Application for Licence Amendment

Licence Number	L4680/1988/13
Licence Holder	FMR Investments Pty Ltd
ACN	009 411 349
File Number	2013/003899-1~9
Premises	Greenfields Processing Site Part mining tenement M15/1836 and Lot 102 on Plan 40393 Great Eastern Highway COOLGARDIE 6429 WA As defined by the Premises maps attached to the Revised Licence in Schedule 1
Date of Report	05/09/2022
Decision	Revised licence granted

- Construction and operation of upstream embankment lift at Cell B and C of Tailings Storage Facility (TSF) 3 from RL402.5m to RL405.0m (Stage 7).

Figure 1: Cell B and C (Stage 7) embankment raise from RL 402.5m to RL 405.0m

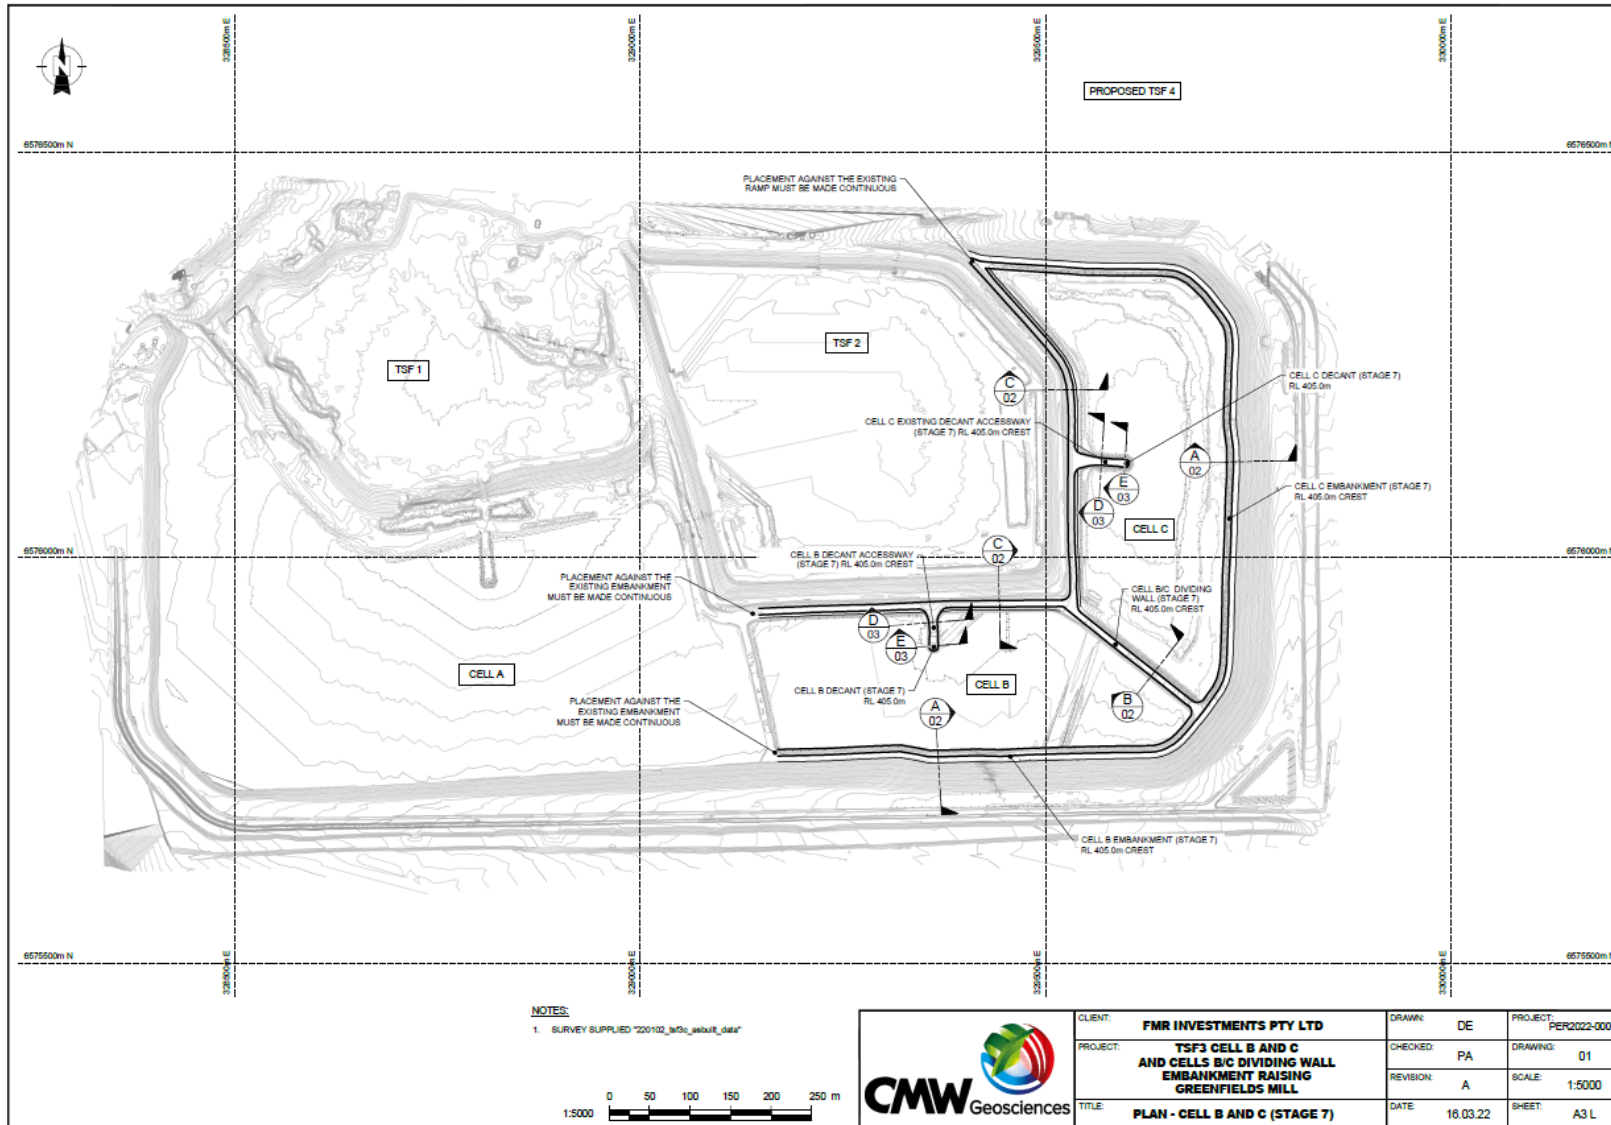
Construction will be undertaken in accordance with the design drawings (Figure 1 and Figure 2) below. At the time of this document, all three cells of TSF3 had a crest level of RL 402.5m. Discharge into Cell A had ceased, and the tailings are in the process of drying. A previous amendment application has been granted by the department for the embankment lift for Cell A and its relating structures including the dividing wall between Cell A and B to a height of RL 405.0m. The stage 7 embankment raise for Cells B and C (from RL 402.5m to 405.0m) will only be undertaken after the Cell A lift, and once the tailings beaches have dried sufficiently enough to safely support the embankments.

Figure 3. SWL trends in monitoring bores associated with Cell B

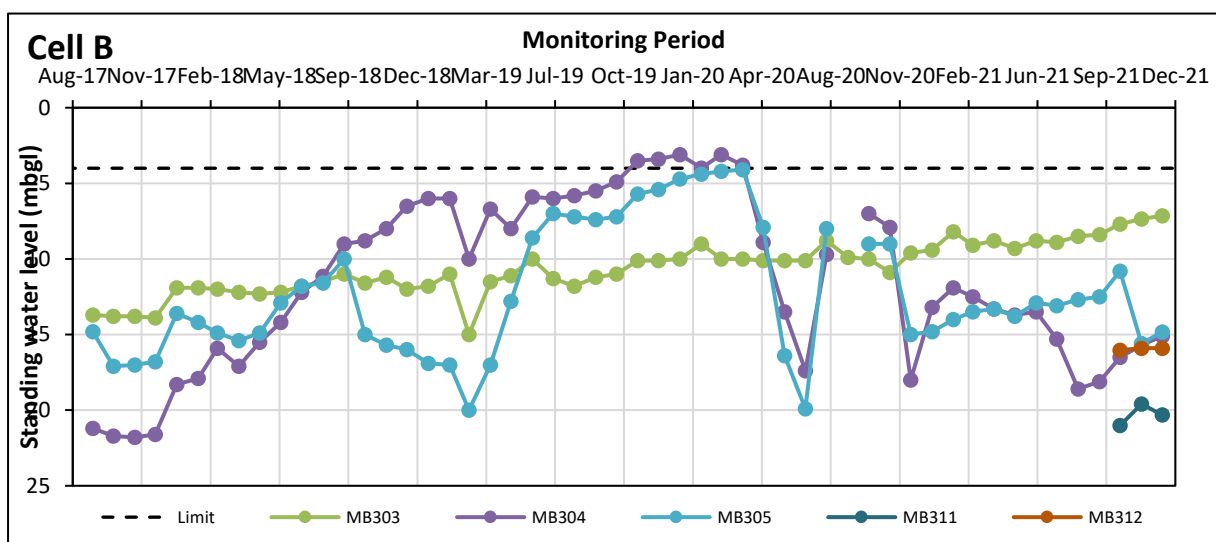
As mentioned above, the natural groundwater of the area has limited uses outside of mining processing. The changes in groundwater from mounding under and around the TSF can cause impacts to adjacent native vegetation. Elevated levels of groundwater due to seepage can impact nearby vegetation by inundation of the root zone by saline water. This can cause severe impacts to health and appearance, and even resulting in death of vegetation. Maximum groundwater levels that were recorded between December 2020 and 2021 varies between 4.2 mbgl to the south of Cell A to 18.9 mbgl in the north-east of Cell C. Historically, SWL have exceeded the 4 mbgl limit in bores along the southern boarder of Cell B, which have since recorded maximum SWL of 10.8 and 11.9 mbgl. Groundwater level trends can be reviewed in Figure 3 and

Figure 4, which provide data from bores associated with Cell B and C respectively. Increasing SWL trends can be observed in all bores associated with these cells, exceeding the licence limit in 2 bores during October 2019 and March 2020. As part of the management plan to ensure more comprehensive monitoring and management of seepage from TSF3, 4 additional monitoring bores were installed south of TSF3. Monitoring of these bores began in October 2021. Since then, the highest SWL recorded in these was 15.8 mbgl to the south-east of the TSF.

The Delegated Officer has assessed the risk of seepage associated with the TSF embankment lifts for Cells B and C. The construction and operation of an embankment lift will increase the pressure of the hydraulic head, subsequently increasing the potential seepage from the TSF. The Licence Holder has seepage monitoring and management actions to observe the rate of the groundwater mounding and act accordingly. Given the nature of the paddock style TSF and previous monitoring recordings, the likelihood for seepage to occur has been assessed as **possible**. The increasing SWL due to seepage can result in further mounding around the TSF to a level where groundwater will impact the root zone of surrounding vegetation. The 4 mbgl limit has been breached in the past, and although there are new management actions in place, it is possible for this to occur again. The consequence rating for this event is considered **moderate** due to the potential for vegetation stress and death. Therefore, the final risk rating for this risk event has been assessed is **medium**. The Delegated Officer has concluded that the Licence Holder controls, and existing licence conditions which have addressed recommendations from DMIR geotechnical advice and the most recent annual audit of TSF3, are acceptable in sufficiently managing the impacts and mitigating the risk of seepage to receptors. No additional regulatory controls are required to manage seepage.
